Groundwater Application Review Summary Form

Application # LL- 1903 REREVIEW

SUBJECT: Scenic Waterway Interference Evaluation

TO: Water Rights Section Date 7/24/2023
 FROM: Groundwater Section G. Fish
 Reviewer's Name
 SUBJECT: Application LL- 1903 REREVIEW **Supersedes review of 11/16/2021**
 Date of Review(s)

Water-Level Measurements in Nearby Wells and Precipitation Trends

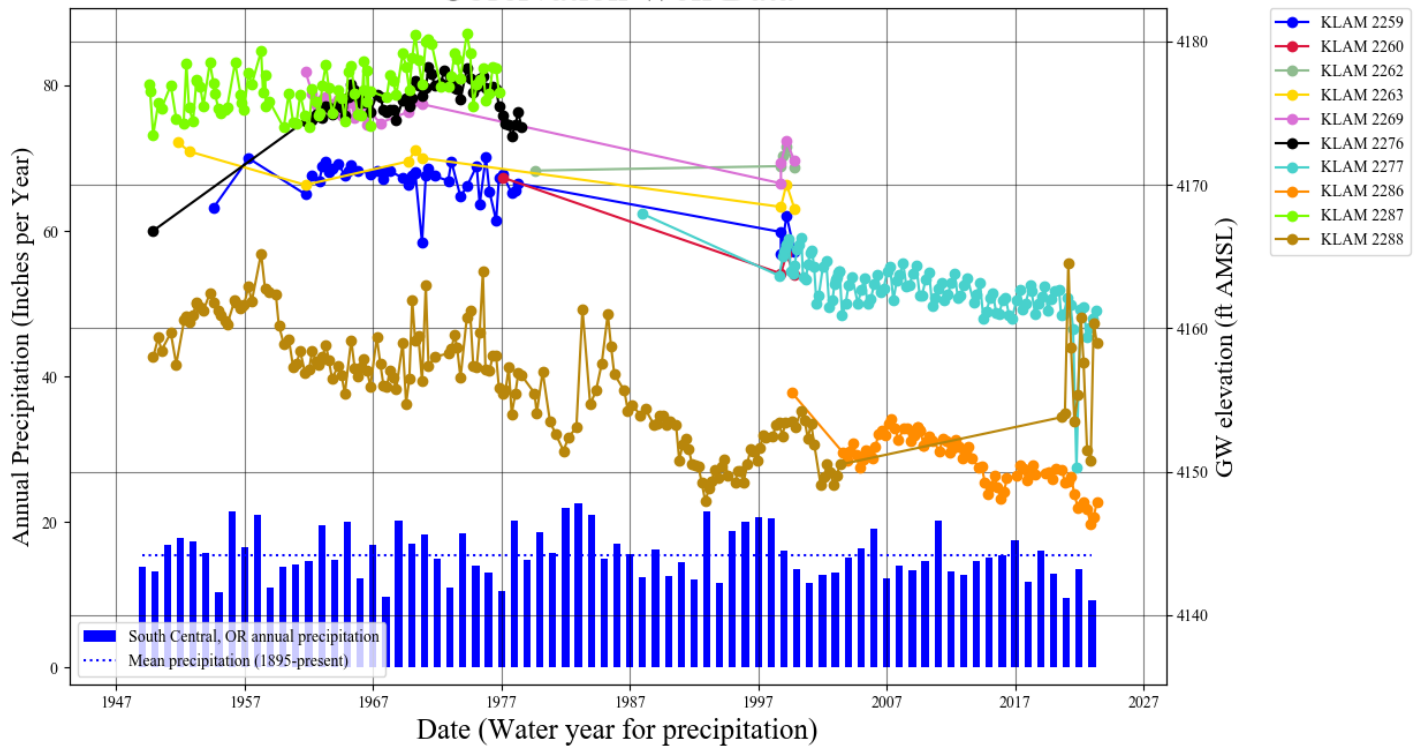
B3. **Groundwater availability remarks:** A comparison of groundwater recharge to groundwater allocation has not been performed for the Swan Lake valley and so groundwater over-appropriation cannot be determined via a water balance analysis but water level data are available for the area. The water level data available show short-term (decadal) variability, suggesting a strong relationship to climate cycles, but an overall decline in groundwater levels of approximately 10 ft over the period of record. It is likely that a portion of the observed declines is due to long-term climate trends but, across the Lost River subbasin, groundwater level declines are correlated to area-wide groundwater pumping, and so it is also likely that a portion of the observed declines is due to groundwater pumping in the vicinity of the proposed POA. Available groundwater level data in nearby wells do not display excessive declines or excessively declining trends. There is not a preponderance of evidence that the target aquifer is over appropriated.

Similarly, there is not a preponderance of evidence that the proposed use would not be within the capacity of the resource and so conditions in B1(d) are recommended.
